**GROWTH MANAGEMENT DEPARTMENT STAFF REPORT**  
**PONTE VEDRA OVERLAY DISTRICT**  
**April 26, 2023 Public Meeting**  
**ARC 2023-04 GATE @ Shoppes of Ponte Vedra Tennis Facility**

**To:** Architectural Review Committee  
**Staff:** Sloane Stephens, Planner  
**Date:** April 11, 2023

**Summary of Request:** Applicant is requesting design approval for the construction of 12 lighted tennis courts and associated facilities that will include a clubhouse, restroom, maintenance shed, and a perimeter fence 6 feet in height along the south and west property boundaries. All relevant application materials are attached to this Staff Report.

North / South Elevation

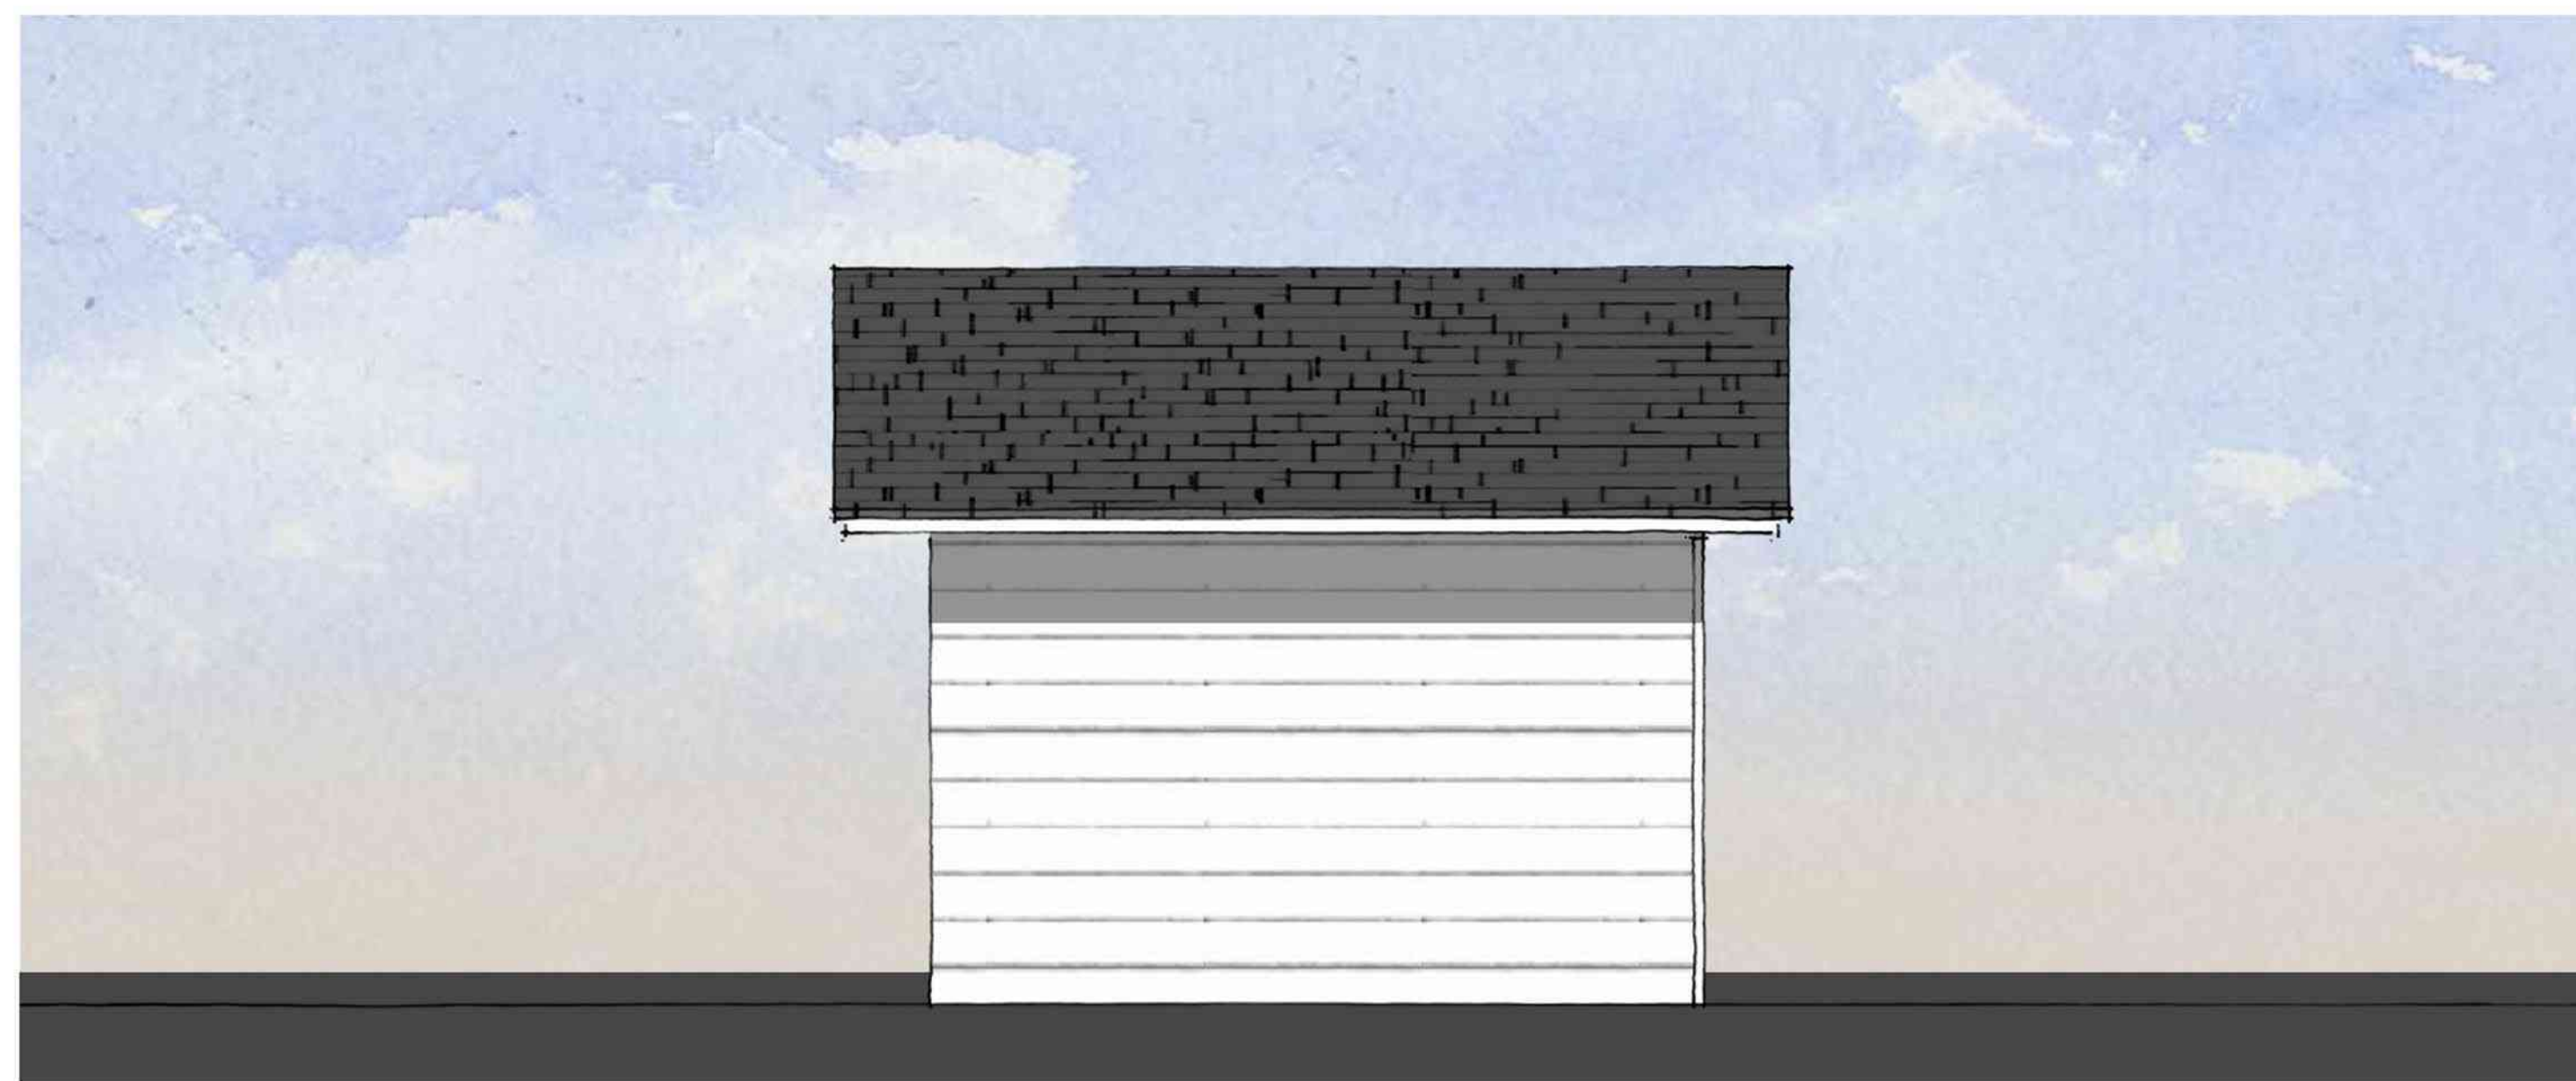
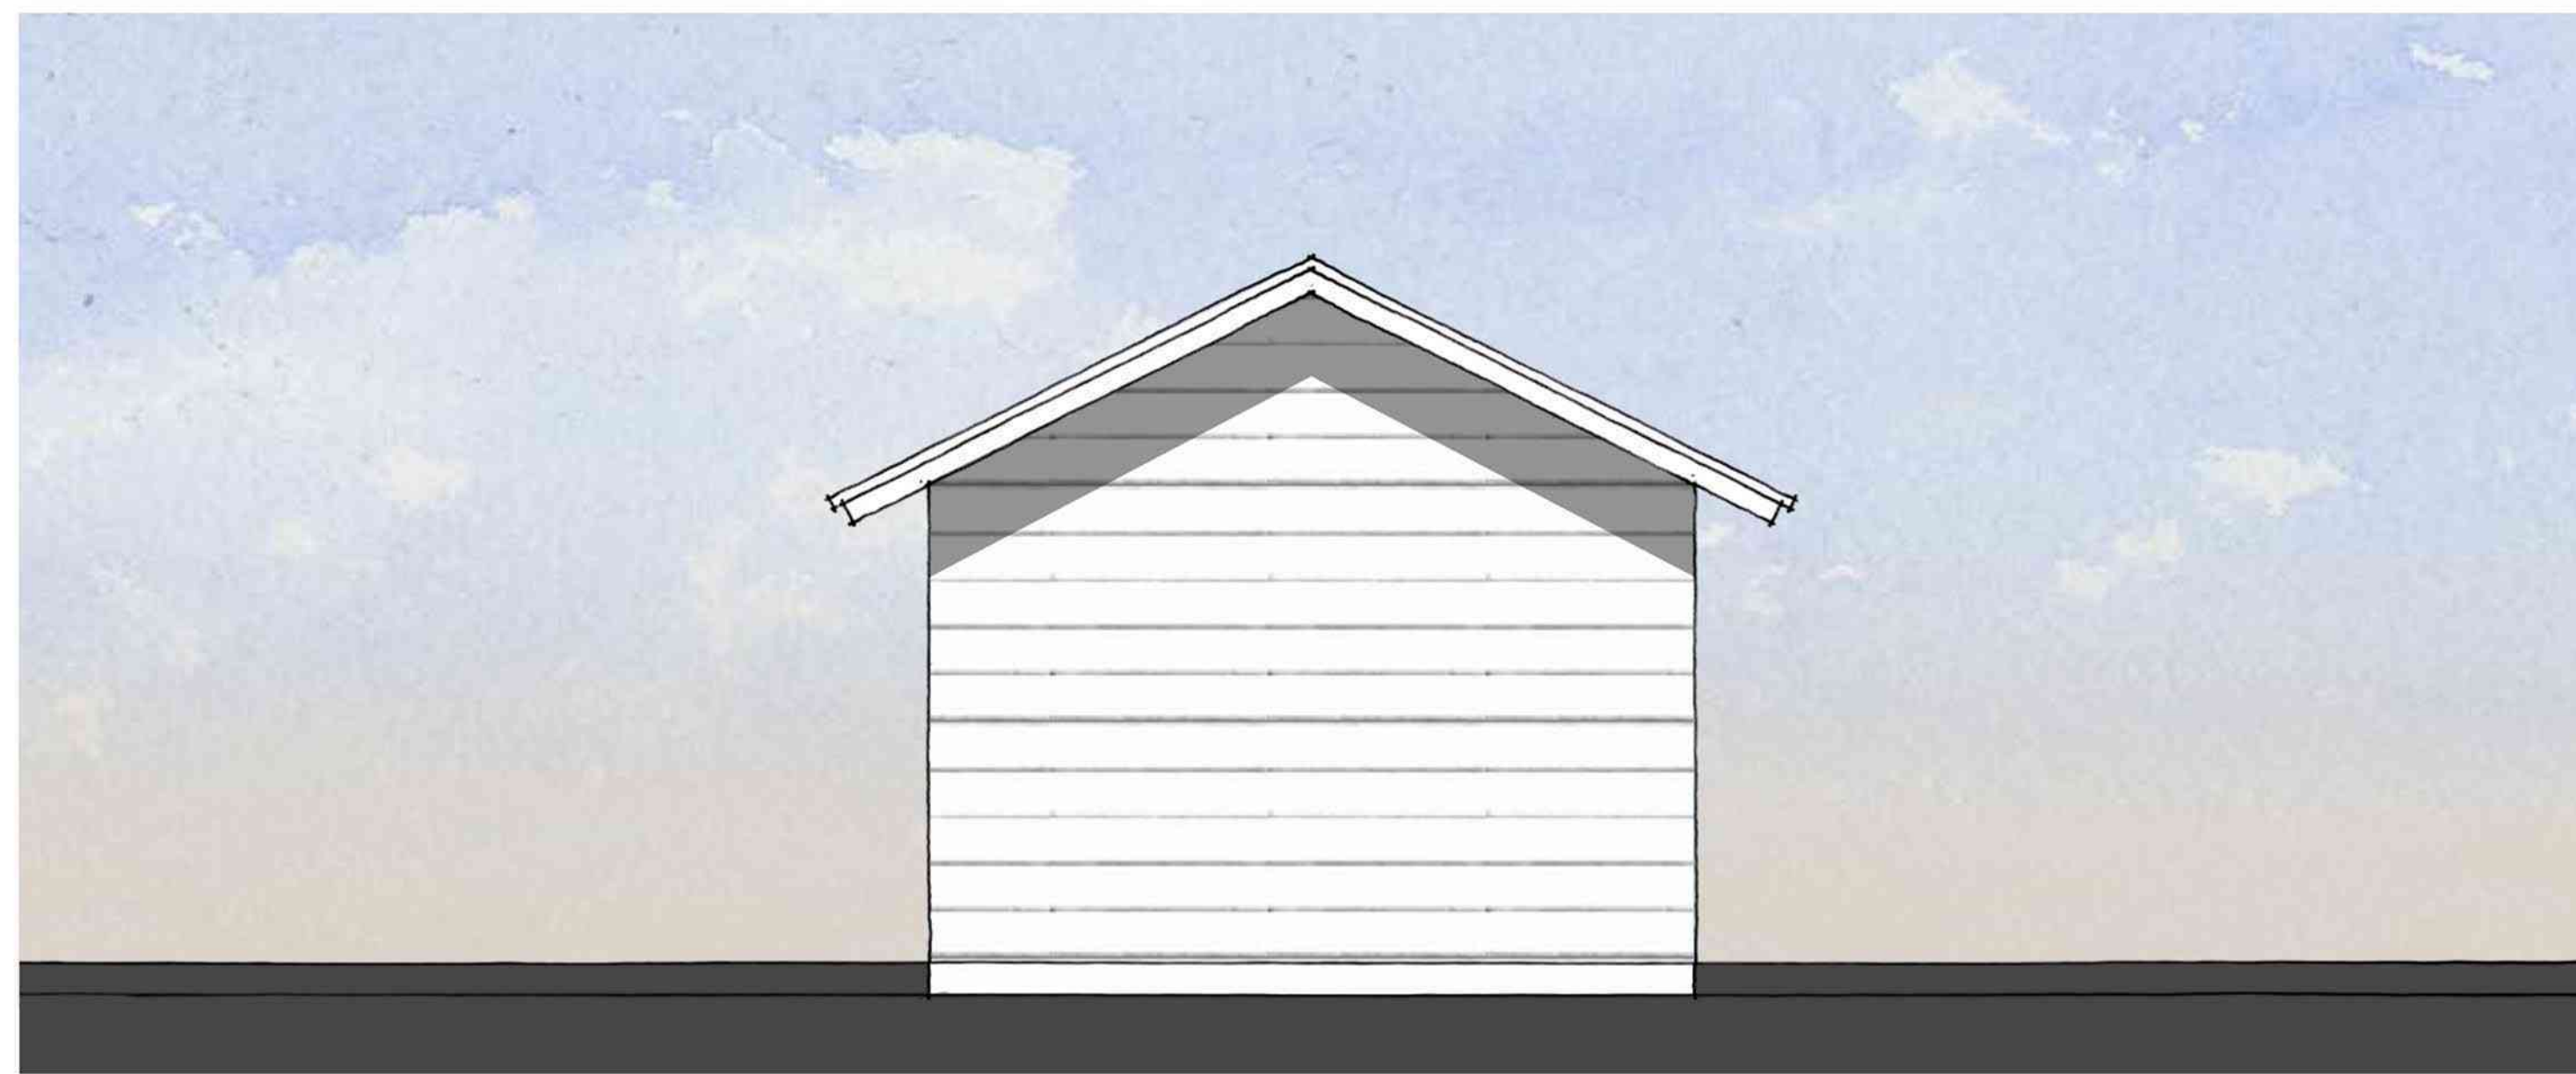
Per PVZDR VIII.Q.5.e.1, flat roofs, or the appearance of flat roofs, shall not be permitted. The roofs of all structures appear to be gable style, which have a pitch. The PVZDR does not state specific pitch requirements.

The proposed colors and materials of the project appear to be consistent with the standards set forth in PVZDR Section VIII.5.d.e. The requirements for the color palette being Earth Tones with no more than three colors per building, excluding roof color, are met.

6' High Board on Board Detail

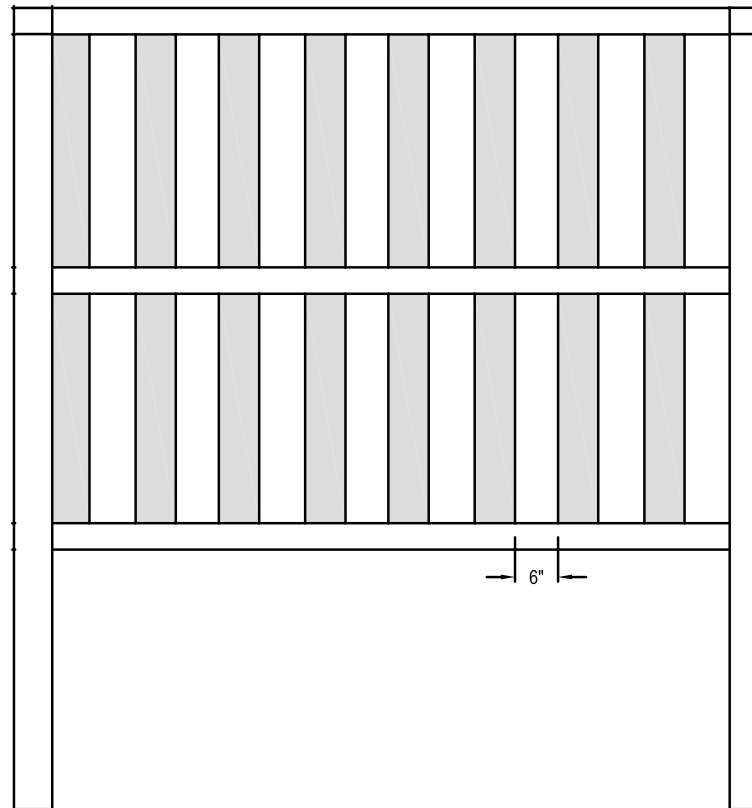
Per PVZDR VIII.N.1.e, in the R-2 and R-3 Zoning Districts, fences may be placed only in the rear and side yard with a maximum height of 6' and a maximum height of any posts/columns, gates, lights, etc. of 8'. The proposed fence height of 6' is in compliance with these regulations. The fencing material is to be board-on-board wood fencing.

The purpose of me reaching out to you this morning is to express my concern for the proposed fence around the perimeter and the concerns for the light and noise pollution caused by the gas station and tennis courts. A wooden fence is not going to hold up in this location. The relentless wind whips through this land clearing on the calmest of days. It's accelerated through this wind tunnel that they have created and pummels our homes each and every day...literally causing physical damage to our homes (I have plenty of evidence, if needed). This wind was never an issue until they de-forested this land. A wooden fence is going to rot and get knocked over and fall apart quickly....it will be done as cheap as possible and not maintained (because that's how Gate treats their neighbors).

If we have to have a fence (many of us don't want one, by the way, because we don't like living behind a man-made prison-like barrier), the neighbors would rather see a classy, black iron or metal fence with thin vertical pickets that allows for plenty of wind to come through. It won't rot and will look so much better. Then, we'd like to see that area behind the fence filled with thick and dense vegetation, like clumping bamboo, so that it will block out the lights, and break up the wind and sounds from the gas station, the tennis courts and the traffic on A1A. We want them to basically restore what we had before Gate unnecessarily took down all of the trees along the perimeter of this parcel....we want them to restore our privacy, but do it in a way that is more natural looking and can help create new ecosystems to try and attract wildlife and animal species that were abruptly displaced by Gate's machinery and de-forestation. Plus, we also want them to do something that is going to help restore some of significant property value that has been lost for the 26 homeowners directly due to Gate's actions.

## Conceptual Buffer Planting Plan (Elevation A-East)

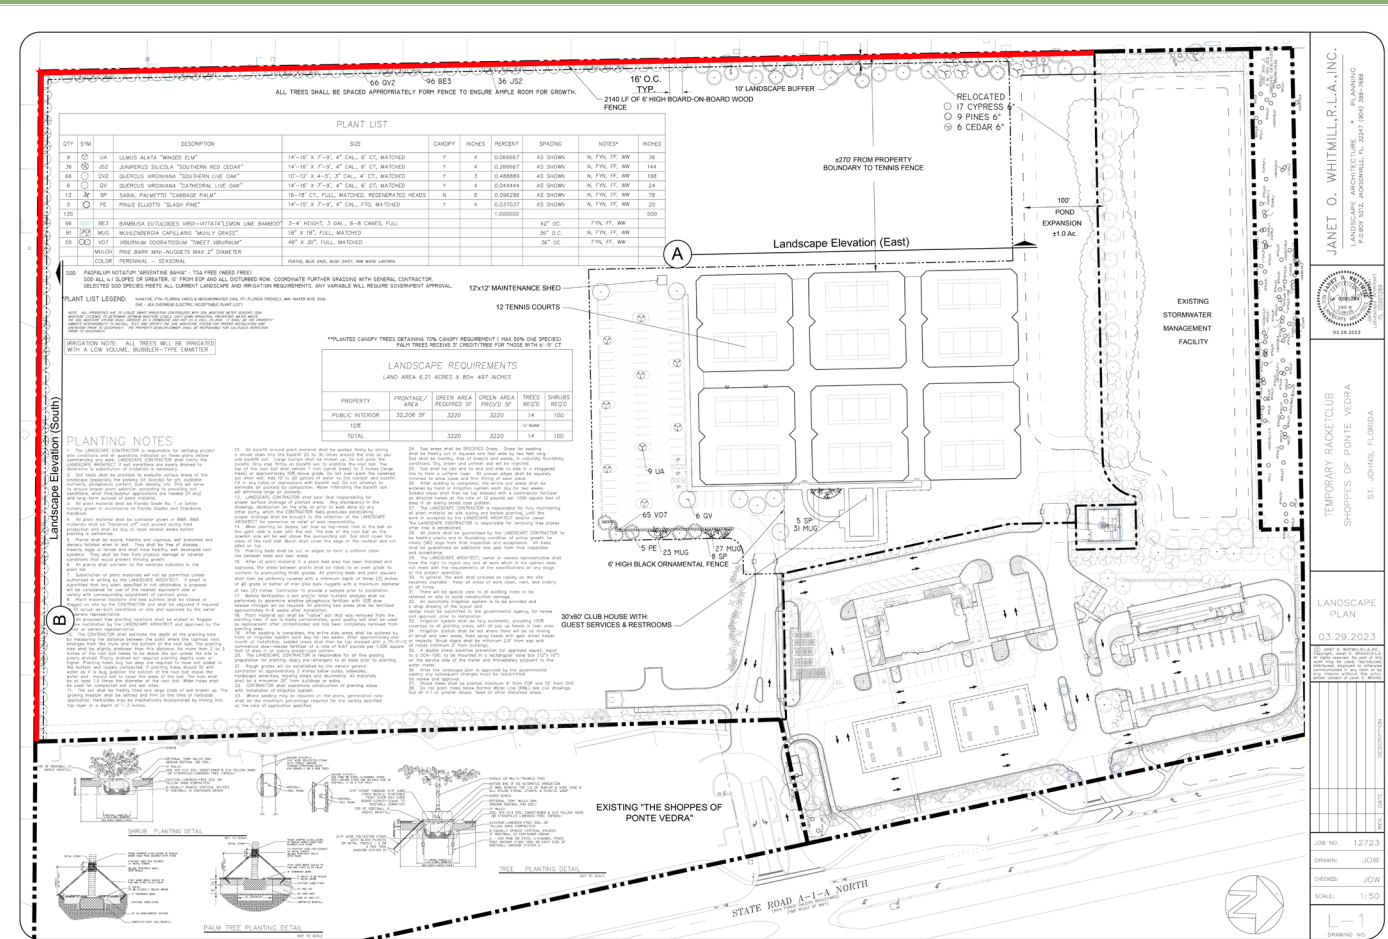
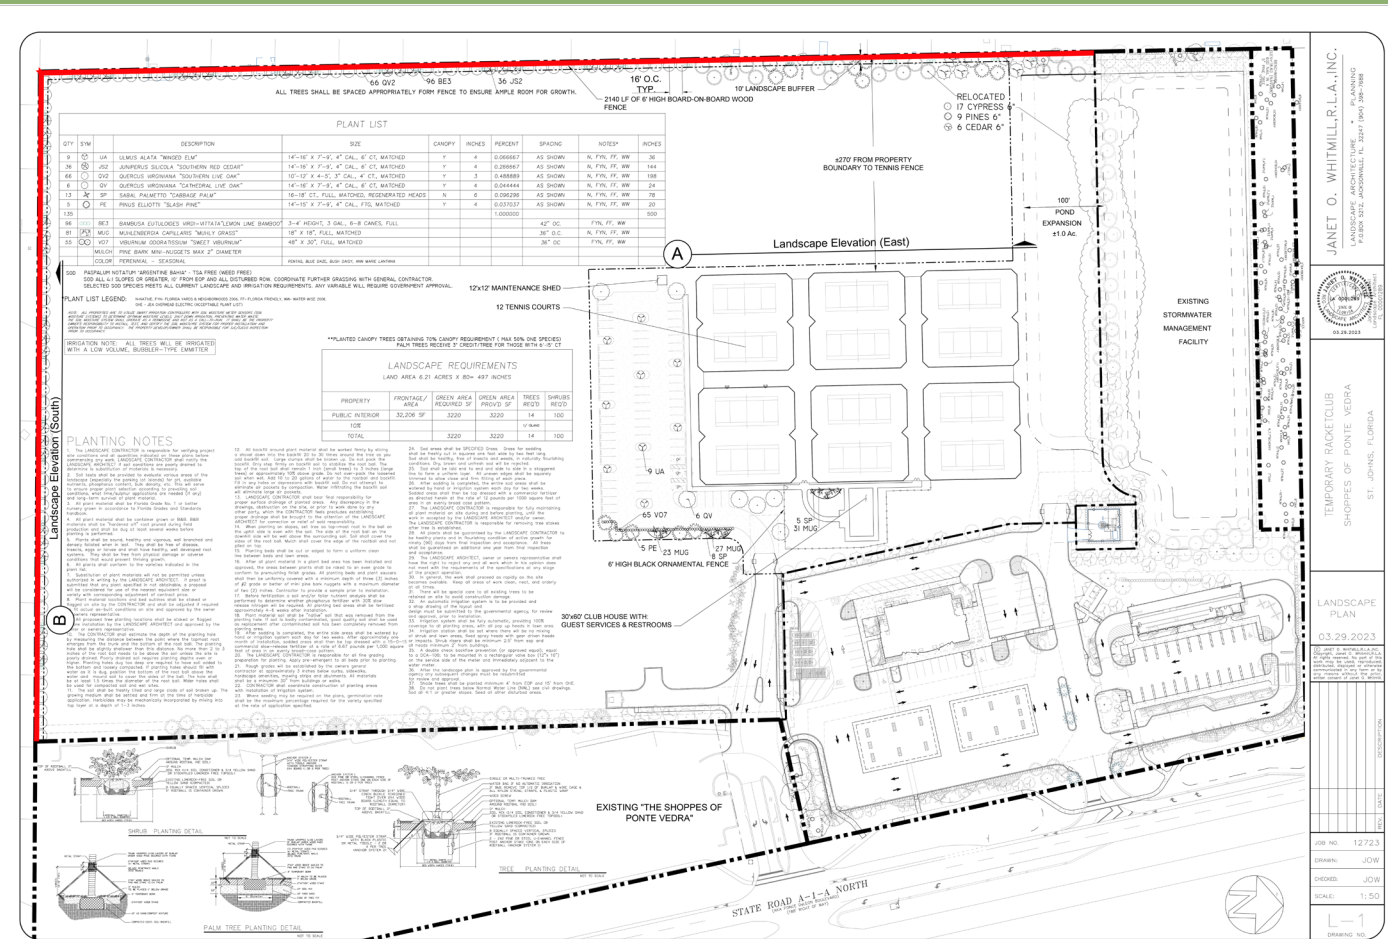
Additionally, PVZDR VIII.Q.5.b(2) requires minimum buffers of 10 feet on the side and rear property boundaries, which is labeled on the proposed landscape plans.
